## **The Factors that Require the Replacement of LANL Monitoring Wells R-6 and R-6i**

By Robert H. Gilkeson, Registered Geologist

Report on December 2, 2009

**Figure 1.** The location of monitoring wells R-6 and R-6i in the eastern part of TA-21

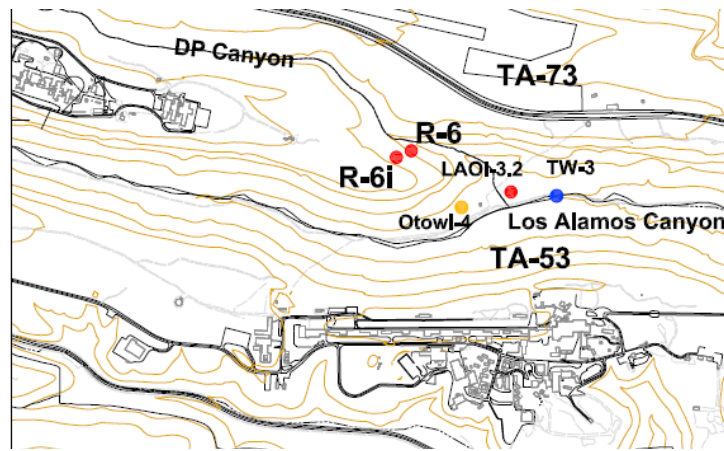
LANL monitoring well R-6i is installed in a perched zone of saturation and is located 20 feet southwest of well R-6 (see Figure 1). The 10 foot long screen is installed in the depth interval of 602 to 612 feet below ground surface. The drilling method invaded the sampling zone in well R-6i with a large quantity of organic drilling foam that was not removed by the well development methods. The drilling additives formed a new reactive mineralogy in the sampling zone with strong properties to mask the detection of trace metals and the LANL radionuclides plutonium and americium. The contaminants detected in well R-6i include perchlorate, tritium, chloride nitrate and sulfate. Other LANL contaminants may be present in the perched zone of saturation but the trends in water quality data are proof that well R-6i is not reliable to detect the full nature and extent of contamination because of the new reactive mineralogy from the organic drilling additives. Well R-6i is not reliable to detect many LANL contaminants including plutonium and americium. **Replacement of LANL monitoring well R-6i is necessary.**

**Introduction.** Figure 1 shows the locations of LANL monitoring wells R-6 and R-6i in DP Canyon ¼ mile northwest of Los Alamos Canyon. Well R-6 was drilled in October of 2004 with the mud-rotary method that pushed a large quantity of drilling muds into the sampling zone for the well. The drilling muds were a mixture of bentonite clay and organic additives. The well development was not able to remove the majority of the drilling muds. The drilling muds created a new highly reactive mineralogy in the screened zone of well R-6 with well known properties to prevent the detection of many LANL contaminants including trace metals, organics, and the strongly sorbing LANL radionuclides including plutonium and americium. The 23-foot long well screen is installed from 1205 to 1228 feet below ground surface (ft bgs). The water table of the regional aquifer is at 1158 ft bgs. The top of the well screen is 47 feet below the water table and too deep to detect contamination at the water table of the regional aquifer.

The physical facts are proof that only a small portion of the bentonite clay and organic additives were removed from the aquifer zone from which well R-6 produces water. Well R-6 requires replacement with three new monitoring wells that are drilled with the correct application of the dual-rotary casing advance drilling method using only air or potable water as drilling fluids. One well shall be installed near the water table of the regional aquifer, the second well shall be installed in the first aquifer zone with high permeability and the third well shall be installed at an appropriate depth in the regional aquifer as a sentry well for the drinking water supply well Otowi-4. The location of well Otowi-4 is displayed on Figure 1. The pair of R-35 monitoring wells that were installed as sentry

Figure 2. Figure 5-11 in *Environmental Surveillance at Los Alamos During 2008*

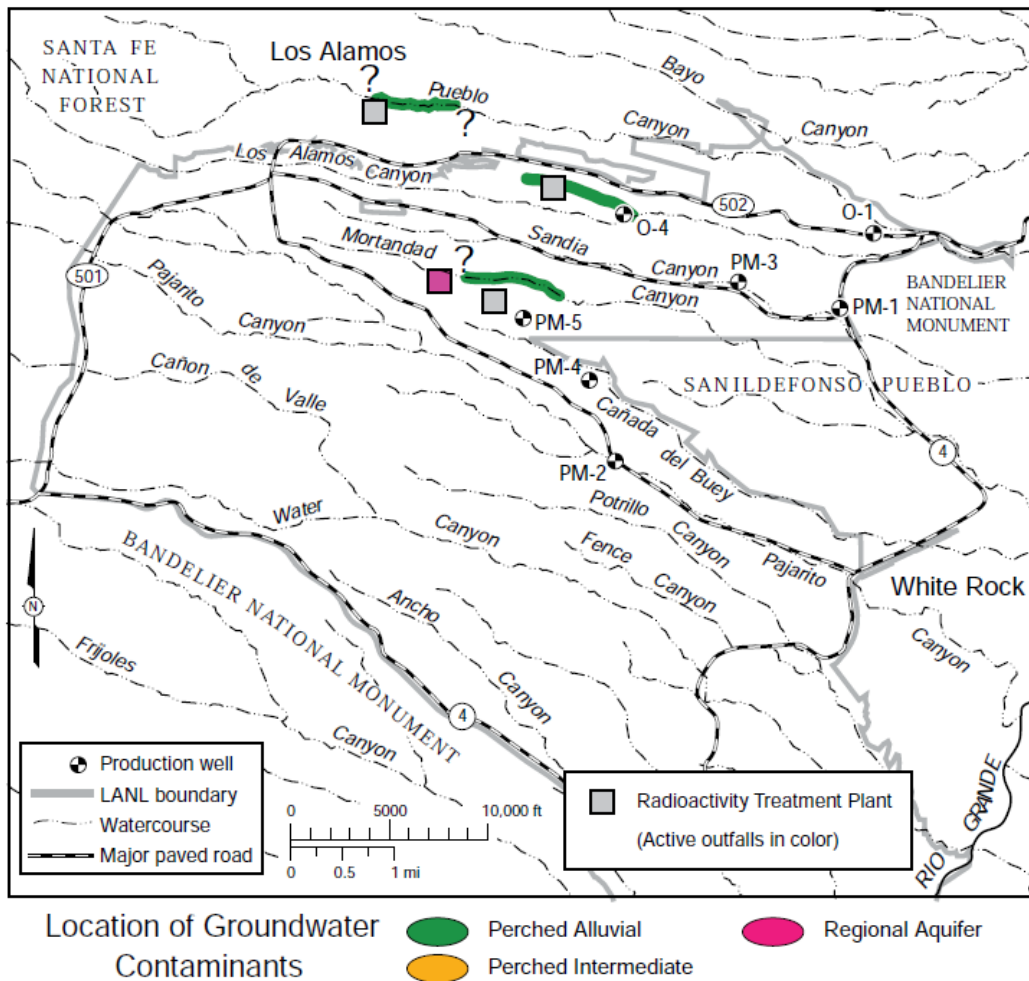
**The mud-rotary monitoring well R-6 is not reliable for detection of LANL contamination present in the wet alluvial sediments present in DP Canyon and Los Alamos Canyon that have migrated to the regional aquifer.** An important requirement at the location of monitoring well R-6 is accurate knowledge of groundwater contamination in the regional aquifer from the highly adsorptive radionuclide contaminants americium and plutonium and also strontium-90. These contaminants are measured in the groundwater samples collected from the water saturated alluvial sediments along DP Canyon east of TA-21 and at the confluence of DP Canyon with Los Alamos Canyon. The one mile long zone of radionuclide contamination in the alluvial sediments beginning at drinking water well O-4 and along DP Canyon west of the confluence with Los Alamos Canyon is displayed on Figure 2 on the next page.

Figure 1 on page 3 of this report shows that well R-6 is located west of drinking water well O-4 in the green zone on Figure 2 where alluvial sediments are contaminated with high concentrations of isotopes of plutonium, americium and strontium.

**Figure 3.** (MDAs) at TA-21 and their SWMU numbers.

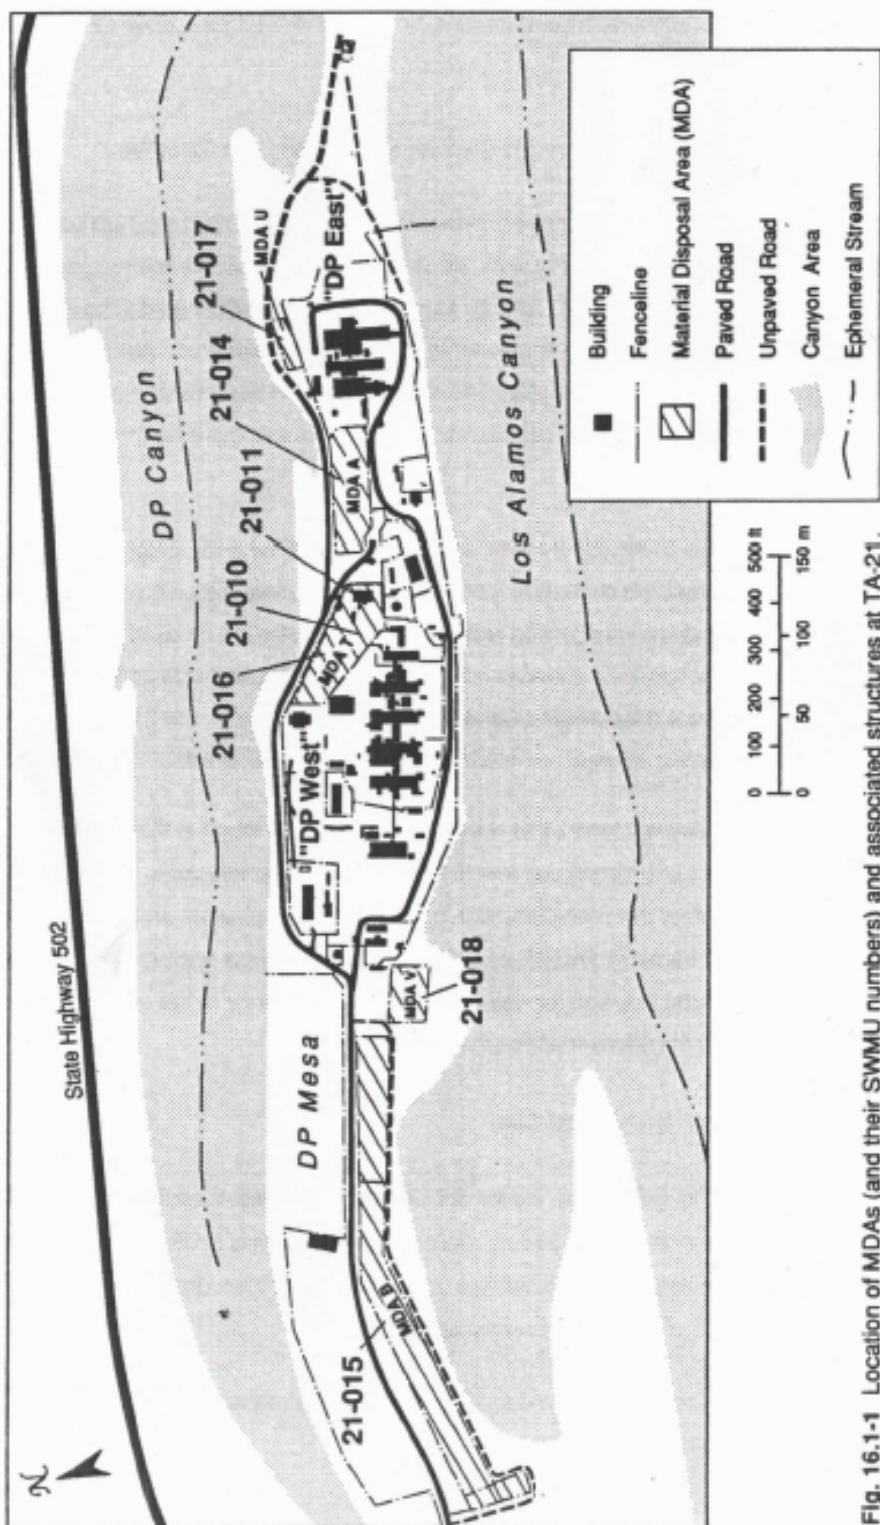
**Well R-6 is too far away from the five legacy waste dumps (MDAs) at TA-21.** Figure 3 on page 12 displays the locations of the five MDAs at TA-21. The direction of groundwater travel in the regional aquifer below TA-21 is from west to east toward monitoring well R-6. The necessary field tests to measure the lateral speed of groundwater travel in the regional aquifer below TA-21 have not been done. The best estimate of groundwater travel in the regional aquifer is described as follows in the LANL Environmental Surveillance Report that was published in 2008:

The locations of the five legacy waste dumps at TA-21 are displayed below on Figure 3. There is an immediate need to install an appropriate network of monitoring wells at TA-21 to investigate and monitor groundwater contamination from the legacy waste dumps and also from the other disposal sites at TA-21 where large volumes of liquid wastes were disposed of in seepage pits, disposal wells and sumps.
